Access Compliance Report Public Rights-of-Way (Curb Ramps)

Main Street: WESTON_PL Cross Street: LAMBETH_WAY Location: NW

ADA ID: RPRK220124121955 Ramp Type: Type 4 - Parallel Initial Pass/Fail: Fail Overall Compliance: No Severity Score: 2

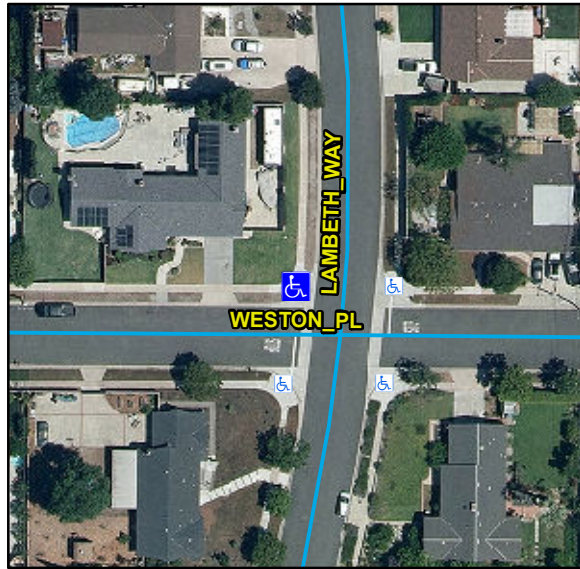
Compliance	Description	Data	Compliance	Description	Data
N/A	Ramp Length LT (in)	85	N/A	Ramp Length RT (in)	85
Yes	Ramp Width LT (in)	124	Yes	Ramp Width RT (in)	124
Yes	Ramp Run Slope LT (%)	4	Yes	Ramp Run Slope RT (%)	7.6
No	Ramp Cross Slope LT (%)	4	Yes	Ramp Cross Slope RT (%)	1.2
N/A	Landing Present	N/A	N/A	DWS Provided	N/A
N/A	Landing Length (in)	N/A	N/A	DWS Contrast	N/A
N/A	Landing Width (in)	N/A	N/A	DWS Length (in)	N/A
N/A	Landing Run Slope (%)	N/A	N/A	DWS Full Width	N/A
N/A	Landing Cross Slope (%)	N/A		DWS Offset Type	N/A
N/A	Landing Movement Obstructed?	N/A	N/A	DWS Offset Left (in)	N/A
	Landing Movement Type	N/A	N/A	DWS Offset Right (in)	N/A
N/A	Landing Shared	N/A			
N/A	Clear Space	Yes			
N/A	Clear Space To Crosswalk (in)	N/A			
N/A	Marked Crosswalk 1	No	N/A	Marked Crosswalk 2	No
	Crossing 1 Direction	S		Crossing 2 Direction	E
	Marked Crosswalk 1 Width (in)	N/A		Marked Crosswalk 2 Width (in)	N/A
N/A	Ramp Inside Crosswalk 1	N/A	N/A	Ramp Inside Crosswalk 2	N/A

Crossing 1 Slope (%)	2		Crossing 2 Slope (%)	4.7
	Crossing 1 Cross Slope (%)	2.4		Crossing 2 Cross Slope (%)	0.5
N/A	Gutter Ponding	N/A	Yes	Curb Slope	2.1
Yes	Gutter Lip Height (in)	0		Road Run Slope (%)	1.2
N/A	Gutter Run Slope (%)	N/A		Road Cross Slope (%)	1.6
N/A	Gutter Cross Slope (%)	N/A	Yes	Perpendicular Joint Present	Yes
Yes	Overall Surface Condition	Acceptable			
	Cross Gutter Present?	Yes		Spandrel Present?	Yes
	Replace Cross Gutter?	No		Replace Spandrel?	No

Remove & Replace Curb Ramp With Two New Directional Ramps or Equivalent.
